Errata

SLG46824

CE-GP-016

This document contains the known errata for SLG46824 and the recommended workarounds.

Figure 1: Example Data

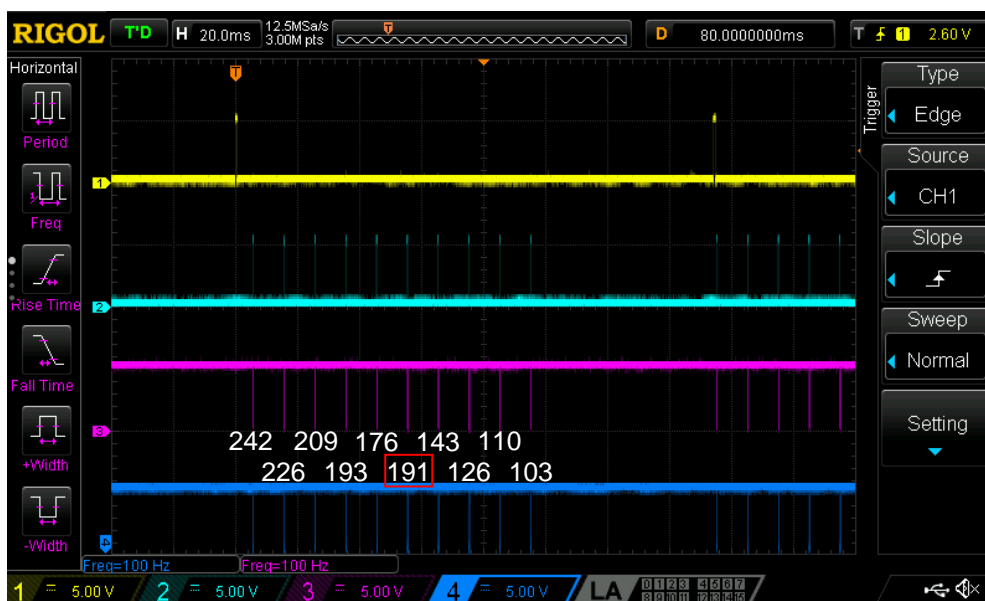
Asynchronous interaction between the CNT/DLY clock input and the I²C latch signal (generated by an I²C read command of the CNT/DLY block's count value) can result in an incorrect I²C data read. The CNT/DLY block will count accurately, but the count value transferred into the block's I²C read register might be loaded incompletely if the I²C latch signal and the clock input occur at about the same time.

The example data capture below shows ten periodic I²C reads of CNT2/DLY2 configured to count down at about 16 clocks per read. The sixth read sample erroneously shows a value greater than that of the fifth. The seventh sample reads as if the previous I²C error never occurred - the difference from the fifth sample (176) to the seventh (143) is 33 clocks or 16 clocks + 17 clocks as expected.

If the possibility of incorrect I²C data reads can't be accommodated for by external software checks, one can guarantee proper operation by stopping the CNT/DLY block's clock during I²C reads through one of the following methods: by disabling the oscillator block, by reconfiguring the CNT/DLY block's clock source, or by gating an external clock using a LUT (Look Up Table) in the signal matrix. After disabling the CNT/DLY block's clock, the count registers can be read without error. Please note that this workaround will add the I²C read and processing time to the counter's overall clock period.

The best workaround depends on the resource constraints of the application. If the oscillator block doesn't clock other logic elements within the design, a matrix output can be used to manually power down the oscillators for the I²C read. When the CNT/DLY block's clock source is routed internally from the oscillator block, I²C commands can temporarily reconfigure the CNT/DLY block's clock source registers to select "Ext. CLK. (From Matrix)." This action will disable the clock by connecting it to ground. If the CNT/DLY block is clocked from the signal matrix, the LUT can be used to gate the clock during the I²C read.

Figure 2: GreenPAK I²C Write Frame for Page Erase

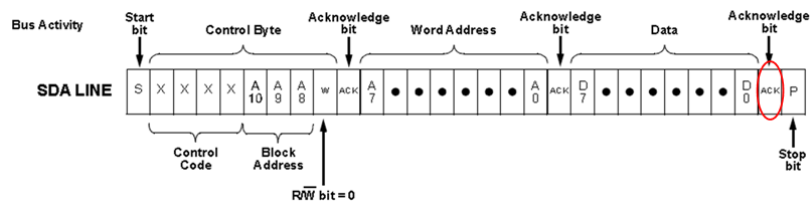
To erase the NVM and the EEPROM, one must perform an I²C write to the "Page Erase Byte" located at 0xE3. The ACK bit which follows the "Data" portion of [Figure 2](#) won't comply with standard I²C specifications. Please see the ACK bit circled in RED below.

No workaround is required for the GreenPAK device as the NVM and EEPROM erase operations will execute properly. For verification, one can perform an I²C read of the erased pages. Excluding protected pages, all erased NVM and EEPROM registers should be cleared.

Adjust the MCU’s I²C firmware to catch and ignore a “NACK” from the GreenPAK device when the “Page Erase Byte” is addressed. In light of the additional STOP and START conditions, the behavior of other I²C slaves on the same bus should be evaluated.

Figure 3: Non-I²C Compliant Behavior Oscilloscope

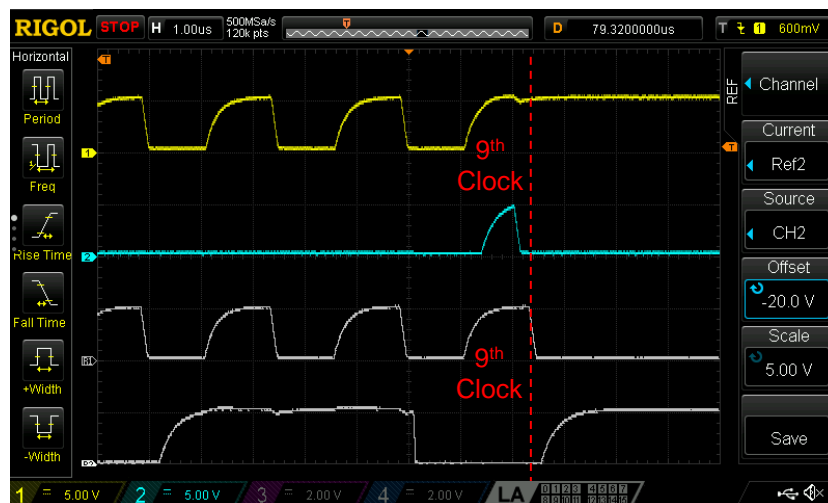
The following waveform compares the regular I²C ACK behavior (Ref 1 - SCL and Ref 2 - SDA) with the non-compliant ACK behavior (Channel 1 - SCL and Channel 2 - SDA) generated by an I²C write to the “Page Erase Byte.” During the 9th clock cycle, the SLG46824 does not adhere to the “data hold time” specification by releasing SDA (Channel 2) before the falling edge of the clock pulse on SCL (Channel 1).

Note 1 It should be noted that the NVM and EEPROM erases will execute properly inside the GreenPAK device despite a potential I²C NACK. In addition, this behavior only applies to the “Page Erase Byte.” All other I²C writes won’t exhibit this behavior.

On a system level, other I²C devices might interpret this non-compliant ACK as an additional STOP and START condition. By definition, a START condition occurs when SCL is HIGH and SDA transitions from HIGH to LOW. A STOP condition occurs when SCL is HIGH and SDA goes from LOW to HIGH. After the 9th clock cycle, the MCU should generate the final STOP condition to indicate the end of transmission to all I²C slaves on the bus.

Figure 4: GreenPAK Input Structure Test Schematic

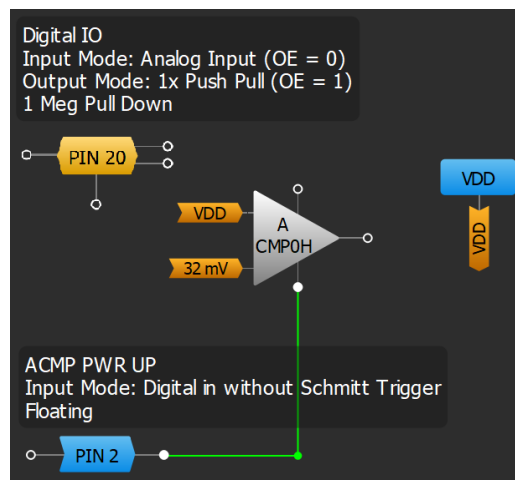
Figure 4 shows the GreenPAK configured with IO14 as a Digital IO with a 1 M Ω pull-down resistor. Since the OE pin is connected to 0 V, this pin is acting as an “Analog IO.” As seen in Table 2, IO14 and V_{DD} are both input options for ACMP0H. In this example, IO0 is being used as a digital input to enable and disable the ACMP.

There is no workaround for this behavior. With this in mind, the IOs should not be used as digital IOs (with "Input mode" set to Analog input) or as digital outputs (with "Output mode" set to 1/2/4x 3-State Output) if the respective ACMP is enabled and connected to another input source.

Figure 5: ACMP Input Structure Behavior

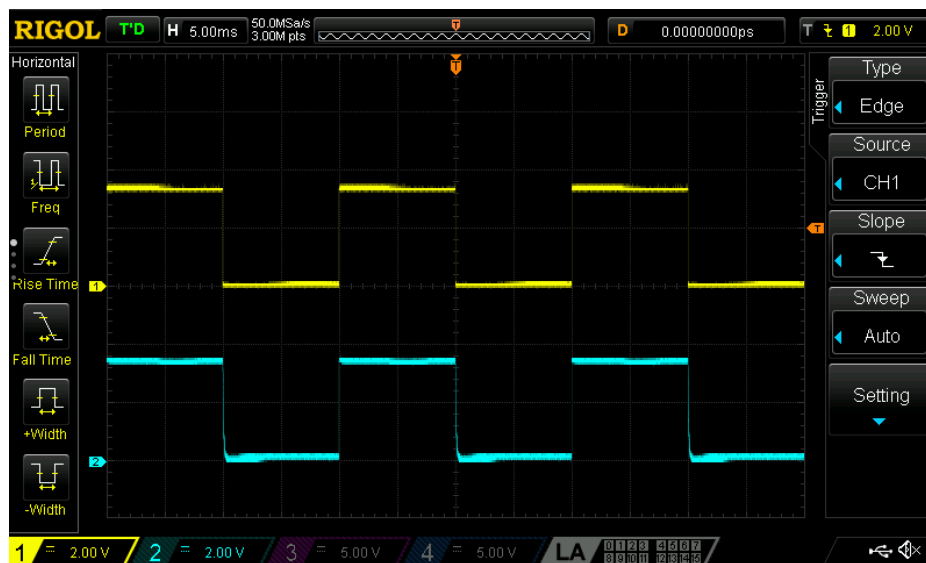
Figure 5 shows that IO14 in analog input mode is pulled HIGH by the V_{DD} signal whenever the ACMP is enabled despite having an internal pull down resistor. This behavior is caused by an internal connection between V_{DD} and IO14. Similar behavior can be reproduced when one ACMP’s IN+ port is connected to another ACMP’s IN+ port.

If an ACMP is disabled, the IO associated with that ACMP will operate as expected under any configuration. Please reference [Table 2](#) for more information regarding which IOs are associated with which ACMPs.

When the ACMPs are enabled, it is possible to inadvertently connect multiple ACMP sources together through the input structure. This is possible when the ACMP input is connected to a source other than its analog IO and that IO's input mode is set to "Analog IO".

Figure 6: Testing Design

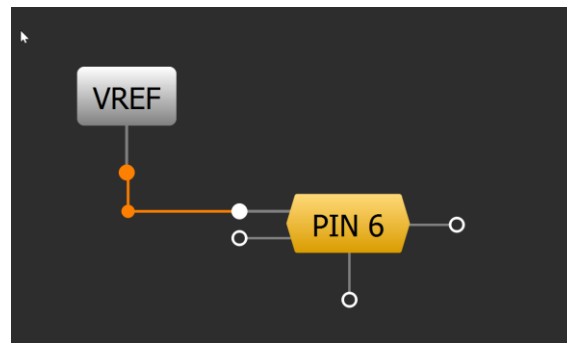
If using Vref output in the range of 32 mV to 192 mV connected to the analog input/output PIN, the Vref accuracy is very low due to the built-in buffer's offset.

There is no workaround.
